**PCO #042**

**Project:** 21-501 - Collin County Adult Detention Facility, Phase 1 Addition  
 4300 Community Avenue  
 McKinney, Texas 75071

**Prime Contract Potential Change Order #042: PR #12 Revised Floor Drains (FD-2) at Tier Level Slab**

## PROPOSAL REQUEST

TIER LEVEL EAST  
 FLOOR PLAN -  
 SANITARY/VENT  
 P231

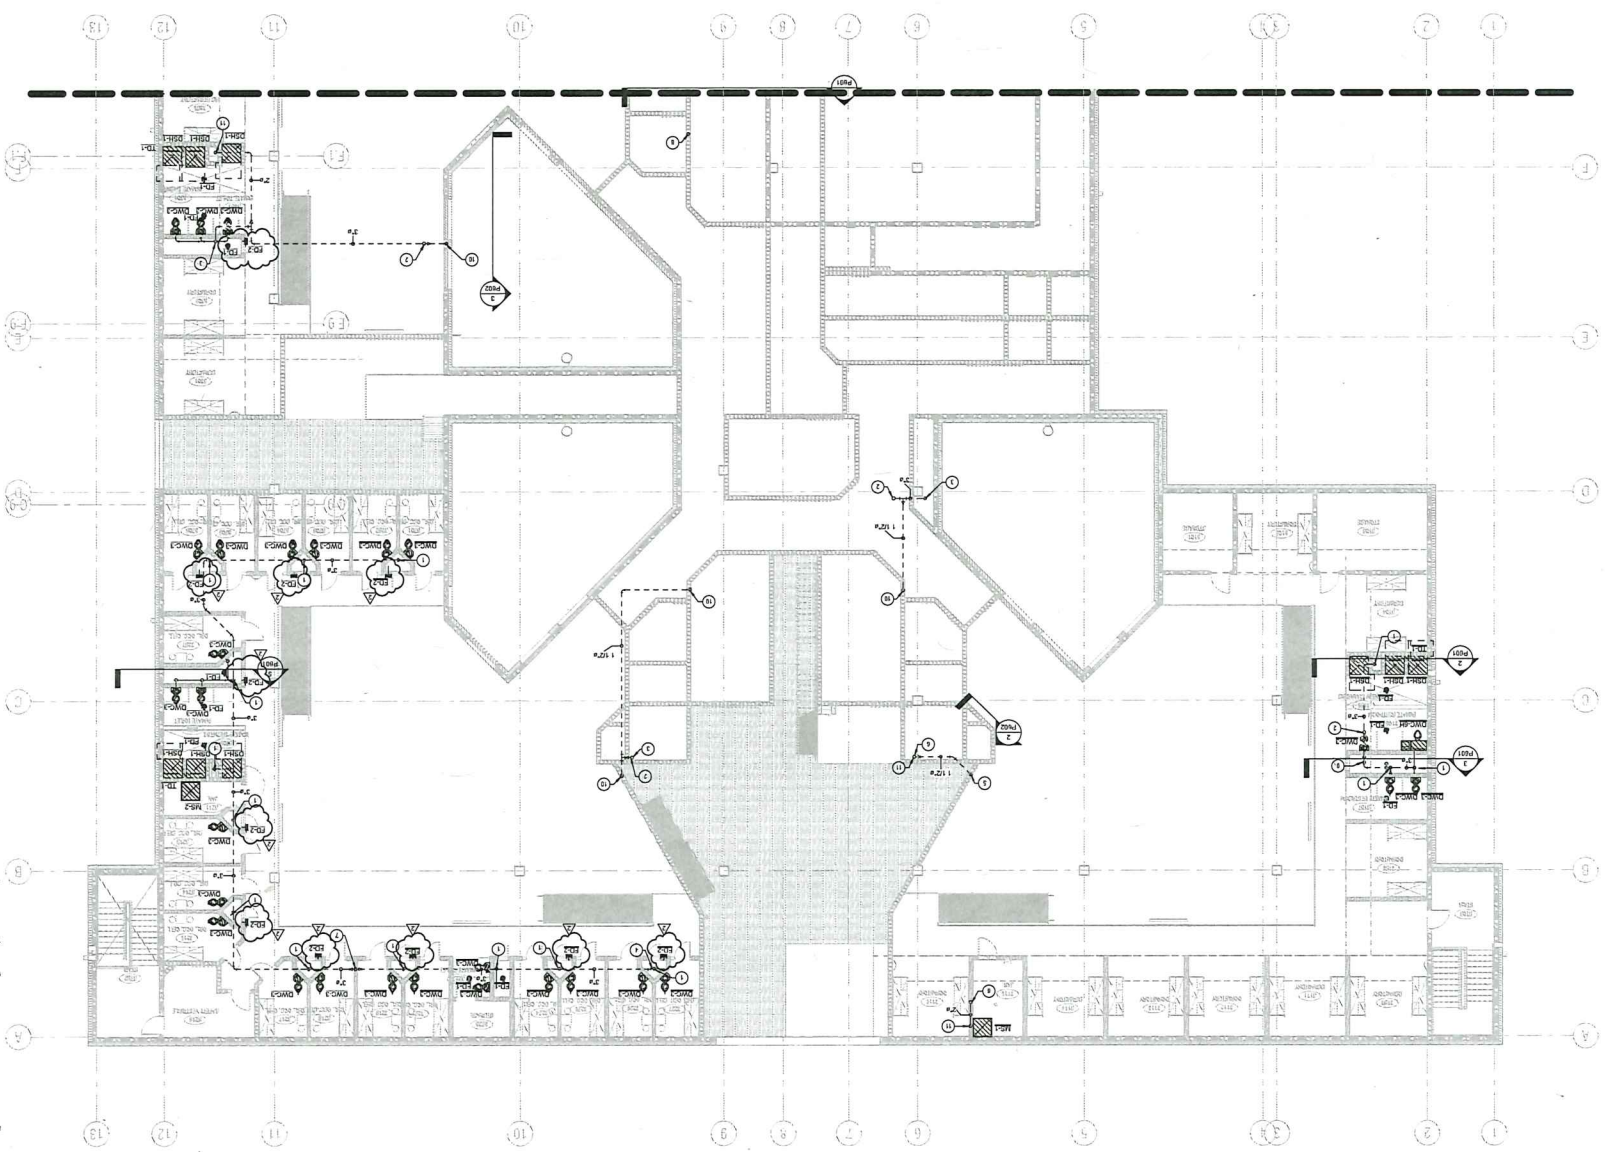
- Item No. 1. At Rec Yard Curbs on Level 1 (all locations): Refer to revised Structural and Architectural details for the curbs in these areas. The curbs are being redesigned so that the brick veneer can bare on structure rather than the insulated topping slab.
- Item No. 2. At Tier Level Slab: Refer to revised Floor drain (FD-2). The current floor drain cannot be cast into the slab due to the mechanical fitting being encased in concrete. Refer to revised plumbing drawings.

Provide for additional material to install new floor drains (FD-2) in the tier level slab as noted in PR #12. Original FD-2 floor drains are onsite and cannot be returned. Unused floor drains to be turned over to Collin County.
